RENESAS TECHNICAL UPDATE

| Product Category | RF Switch IC | | Document No. | TN-LRF-A001A/E | Rev. | 1.00 |
| Title | 6pin Super Minimold Packaged Switch IC Change of Manufacturing Base (Addition) | | Information Category | Change or addition of Production Line | | |
| Applicable Product | UPG2214TB, UPG2179TB | Lot No. | Reference Document | | | |

ϕ 330mm Shipment reel drawing (MOST manufactured product)

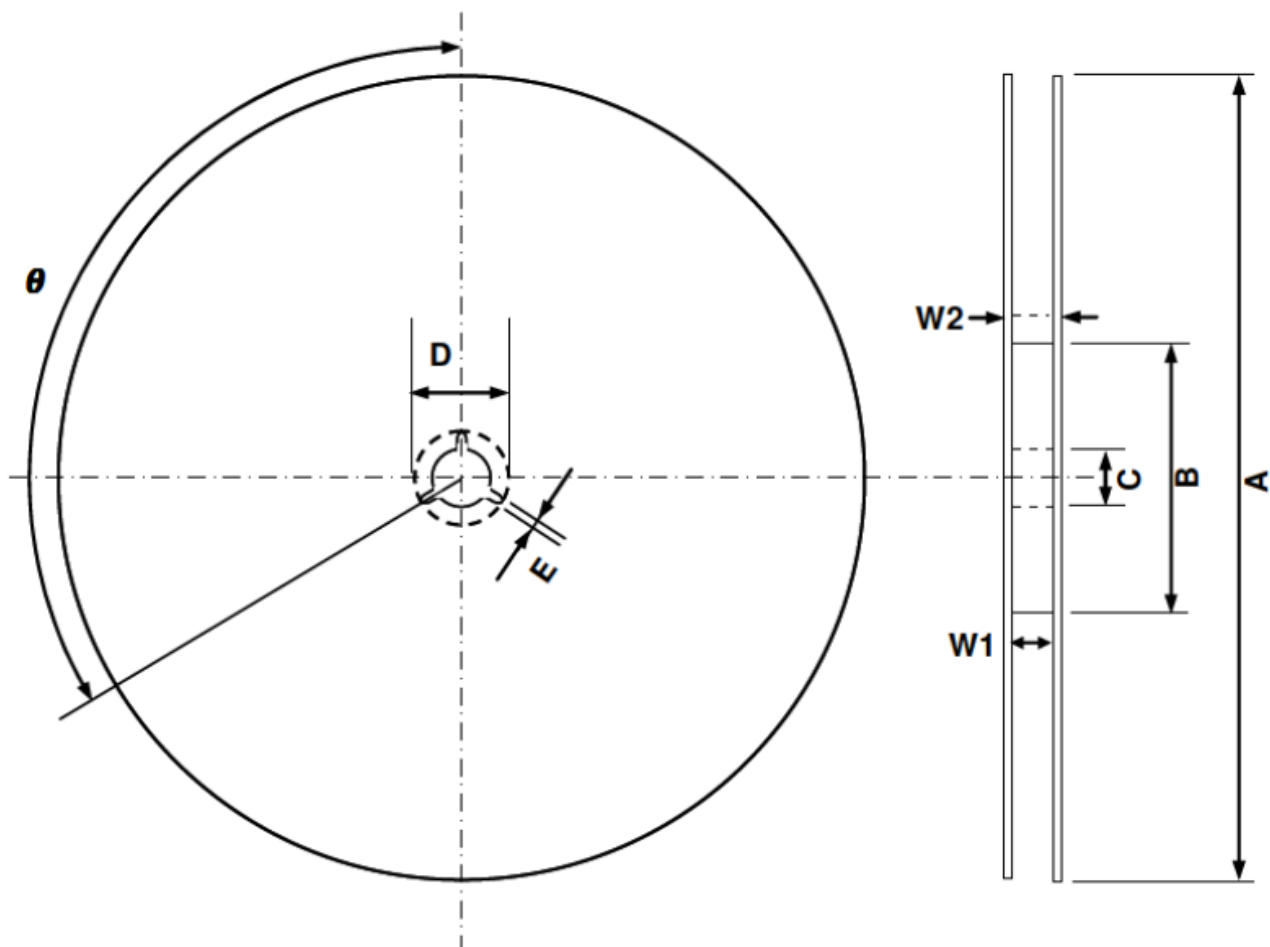
As for the products manufactured by MOST, the key changes from the products manufactured in Japan are as follows,

- Product quantity per reel: 10kpcs
- Shipment reel: Please refer to an attached drawing.
- Part number: UPG2214TB-E4A, UPG2179TB-E4A
